### TE Connectivity

**Product Change Notification:** P-17-014248

2mm HM connector

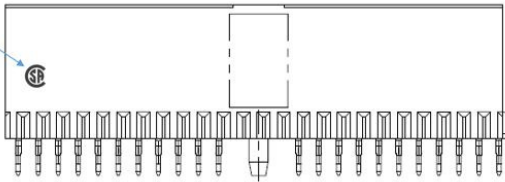
The products will be added a CSA mark on plastic.

Product improvement. 2mm HM connectors had passed CSA (Canadian Standards Association) certification since 1996, but CSA mark was not added on product. CSA request to add CSA mark on each connector.
